## Technical Bulletin

### Bobcat Software Upgrade v1.4 to v1.5 (ECO 3181, CE00126)

**Product:** Bobcat Routing Switcher

**Date:** February 28, 2001

Figure 1. Orientation View

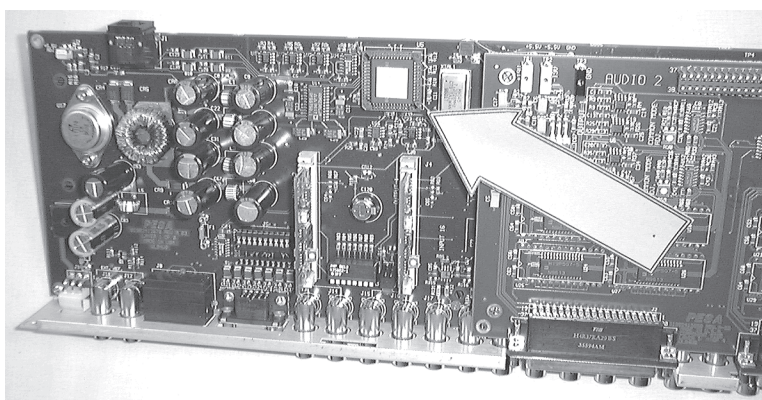
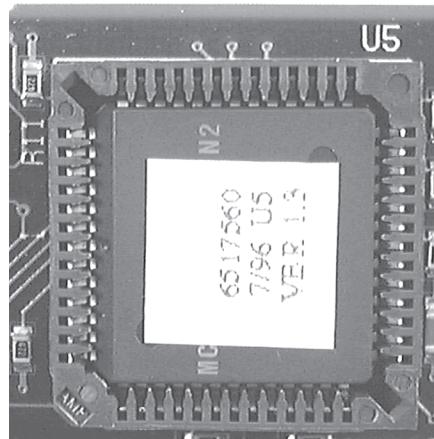
**Issue:** U5, a single chip microcontroller on the Bobcat motherboard, requires replacement to upgrade the software from v1.4 to v1.5.

1. If your Bobcat has push buttons on the front panel, remove the four screws (two on the top plate and two on the bottom plate) that secure the front panel to the chassis. If your Bobcat does not have push buttons on the front panel, skip to Step 3.
2. Disconnect the cable from the RJ-45 connector on the front panel and carefully lay the front panel aside.
3. Remove the two screws on the back which secure the motherboard to the chassis and remove the motherboard.
4. Locate U5 on the motherboard as shown by the arrow in Figure 1.

5. Using a PLCC removal tool, carefully remove the microcontroller from the socket.
6. Orient the new microcontroller for insertion into the socket by aligning the dot on the microcontroller with the “1” silk screened on the printed circuit board (on the left side in Figure 2). This should also bring the chamfered corner of the microcontroller into alignment with the corresponding corner of the socket (lower left corner in Figure 2).
